RAPHAEL COURT SUBDIVISION

APPLICATION NUMBER 11 DATE November 16, 2006

REQUEST Subdivision

DETAIL SITE PLAN

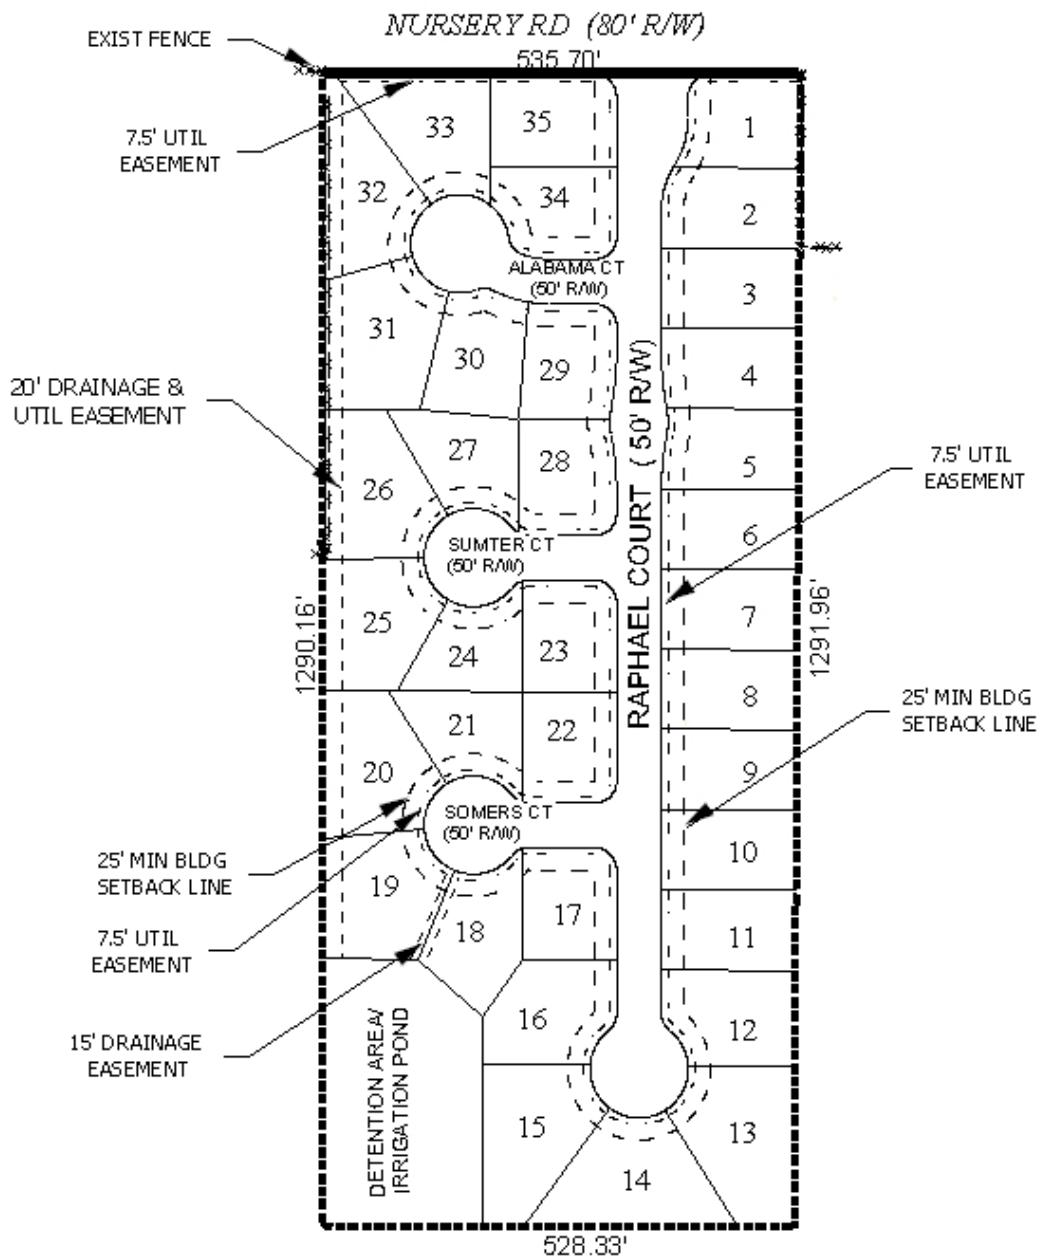
The purpose of this application is to create a 35-lot subdivision from a portion of a metes and bounds parcel. The preliminary plat depicts the proposed subdivision, but does not illustrate the remaining approximately 144+ acres as future development. The plat must show the property from which it is being subdivided.

A traffic calming device (traffic circle) has been depicted on the preliminary plat. The block lengths and maximum length for a closed end street provided within the development meet the minimum requirements of Section V.C.1. of the Subdivision Regulations.

One detention area is depicted on the preliminary plat. The plat illustrate a 15' drainage easement to the detention area, but does not specify that the easement is also to provide access from maintenance of the detention area. Additionally, the detention area and the traffic circle should also be denoted as common areas, as is the entrance median, and a note should be place on the final plat, if approved, stating that maintenance of all common areas shall be the responsibility of the subdivision's property owners.

It appears that each lot meets the minimum size requirements for developments with access to public water and sewer. It is requested that the applicant revise the preliminary plat to provide the size of each lot in square feet on the plat, either as a table or as a label for each individual lot.

Lots 1, 33 and 35 have frontage on the streets proposed within the subdivision, as well as frontage on Nursery Road. The preliminary plat notes that these lots are denied Direct access to Nursery Road. Also, the plat does not reflect the required 25' setback from Nursery Road for Lots 1, 33 and 35.

Based upon the preceding, it is recommended that the plat be granted Tentative Approval subject to the following conditions: 1) the remainder of the parent parcel be shown as future development on the final plat; 2) placement of a note on the final plat stating that subdivision of the future development area will require dedication along Wulff Road, if adjacent to Wulff Road; 3) clarification of the drainage easement to the detention area to include ingress and egress for maintenance; 4) the detention area, traffic circle and median entrance be labeled as common areas, and a note placed on the final plat stating that maintenance of all common areas shall be the responsibility of the subdivision's property owners; 5) provision of a certification letter from a licensed engineer to the Planning Section of Urban Development, certifying that the stormwater detention, drainage facilities, and release rate comply with the City of Mobile stormwater and flood control ordinances, prior to the signing and recording of the final plat; 6) depiction of the size of each lot in square feet on the plat, either as a table or as a label for each individual lot; 7) placement of a note on the final plat stating that Lots 1, 33 and 35 are denied direct access to Nursery Road; 8) placement of the required 25' setback along Nursery Road for Lots 1, 33 and 35; and 9) placement of a note on the final plat stating that any lots which are developed commercially and adjoin residentially developed property must provide a buffer, in compliance with Section V.A.7. of the Subdivision Regulations.
